Project	IEEE 802.16 Broadband Wireless Access Working Group < http://ieee802.org/16 >	
Title	Unique Randomizer Initialization for Interference Management in 802.16 OFDM PHY	
Date Submitted	2004-03-18	
Source(s)	Adam Kerr, Paul Petrus ArrayComm, 2480 North First St. San Jose, CA 95131-1014	Voice: 408-428-9080 Fax: 408-428-9083 E-mail: adam@, petrus@arraycomm.com E-mail: hassan.yaghoobi@intel.com
	Hassan Yaghoobi Intel Corporation	
Re:	IEEE 802.16-REVd/D3-2004	
Abstract	Describes changes to initialization vector for randomizer in OFDM-256 PHY.	
Purpose	These changes will provide for improved detection of error at the PHY level in low reuse networks.	
Notice	This document has been prepared to assist IEEE 802.16. It is offered as a basis for discussion and is not binding on the contributing individual(s) or organization(s). The material in this document is subject to change in form and content after further study. The contributor(s) reserve(s) the right to add, amend or withdraw material contained herein.

Unique Randomizer Initialization for Interference Management in 802.16d OFDM PHY

3) Figure 192 is replaced with:

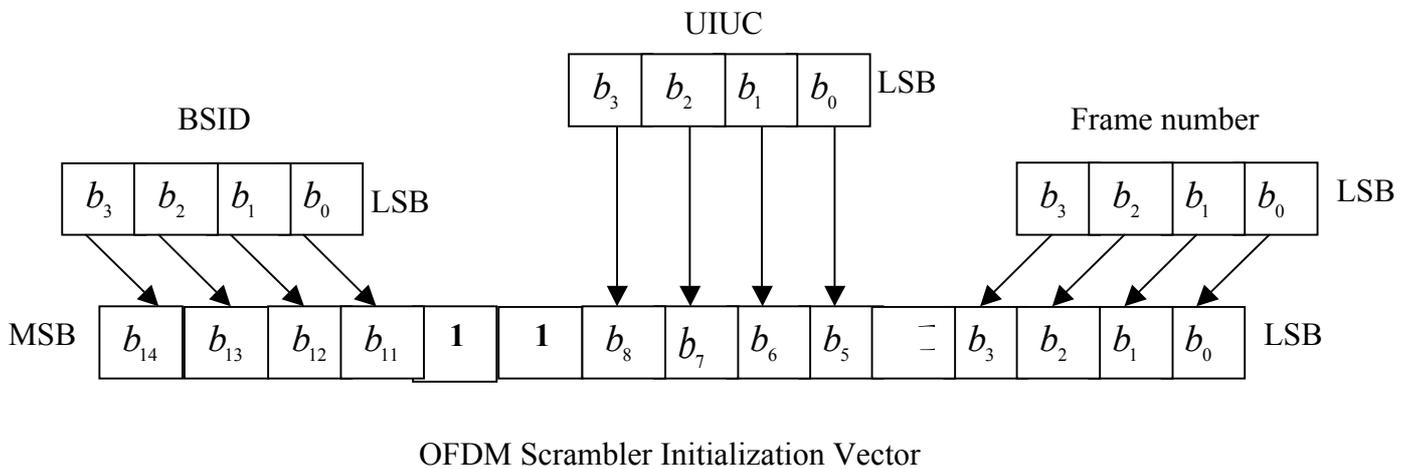
1) The paragraph immediately above Figure 192 is changed to read:
 “On the downlink, the randomizer shall be re-initialized at the start of each frame with the vector: 1 0 0 1 0 1 0 1 0 0 0 0 0 0. The randomizer shall not be reset at the start of burst #1. At the start of subsequent bursts, the vector shown in Figure 192 shall be used to initialize the randomizer. ~~The OFDM symbol number (i.e. the number of the first OFDM symbol of the data burst) shall be counted from the start of the DL subframe, the first symbol being counted as symbol #0.~~ The frame number used for initialization refers to the frame in which the start of the downlink burst is transmitted.”
